SERVICE BULLETIN

No. 66-73

CHOKE COIL BINDING

1966
PLYMOUTH
MODELS
EQUIPPED
WITH
225
CUBIC INCH
ENGINE
AND
HOLLEY
CARBURETORS

Figure 1. - CHOKE COIL IN STUCK POSITION

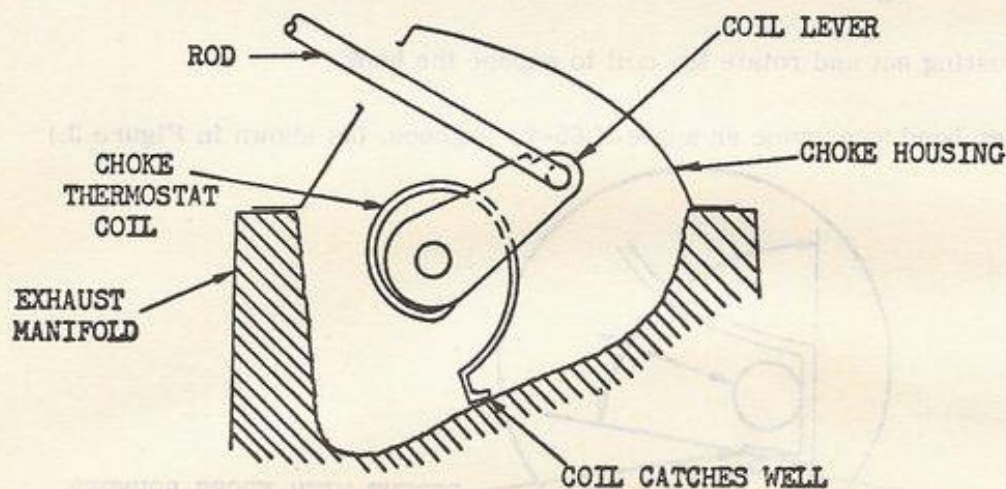
If you experience a starting problem on 1966 Plymouth cars equipped with 225 cubic inch engines and Holley carburetors, it may be due to choke coil to choke well interference as shown in Figure 1. The end of the choke coil catches on rough projections in the cast choke well as it cools down thus preventing the choke from closing. This condition can sometimes be detected by observing bright marks on the bottom of the choke well where the coil has been contacting the surface. If the choke coil is removed while it is caught on the surface of the well a "twang" can be heard as the coil breaks loose while the choke unit is being loosened.

A production change is being made to reduce the coil radius so the interference will not occur. Until the new coils are available, Holley are reworking all choke units in their plant by bending the end of the coil to prevent the sharp end from contacting the pocket. The original choke units are identified by 3283 stamped on the cover. Chokes reworked by Holley will carry the number 3283-1. Chokes with the new coils will have 3283-2 on the cover.

Figure 2. - UNDISTORTED COIL AT 75° F

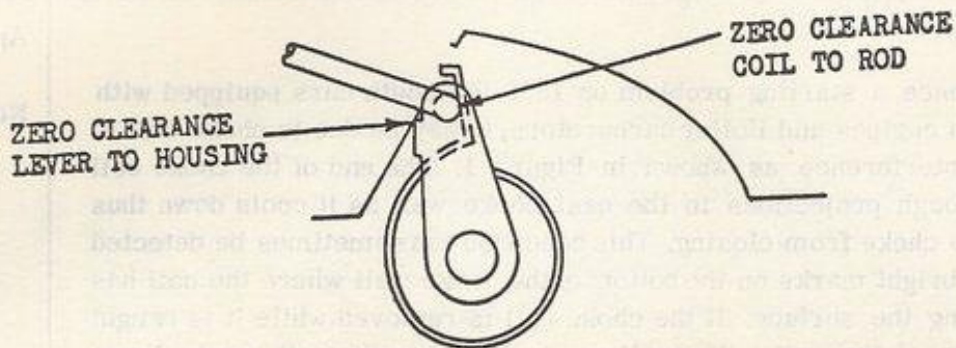
2. The choke coil should then touch the rod when the rod is in its extended position as shown in Figure 2. If such contact does not exist, the coil has been distorted and a new choke assembly part number 2658398 should be used. Rework either the original choke unit if the coil is undistorted or the new 3283 assemblies as described below. (New assemblies with 3283-1 or 3283-2 numbers require no rework).

Figure 3. - CHOKE THERMOSTAT HOOK

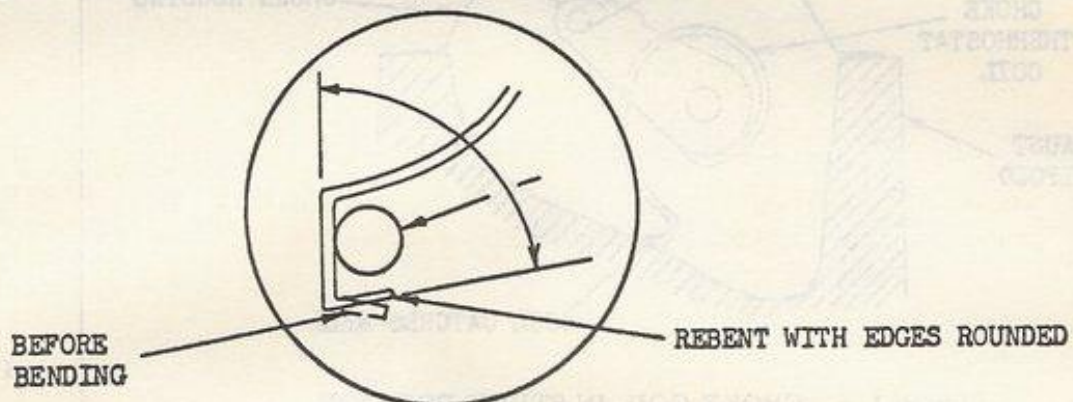
3. Loosen the adjusting nut and rotate the coil to expose the hook.
4. Change the outer bend to provide an angle of 65-75 degrees. (as shown in Figure 3.)

5. Round the sharp outer hook edges with a file.
6. Return the index disc to the 2 notch rich position. Check to make sure the bottom of the hook contacts the choke rod rather than the bent end.
7. Tighten the locknut.
8. Install the choke, making sure that all of the choke mechanism operates freely.
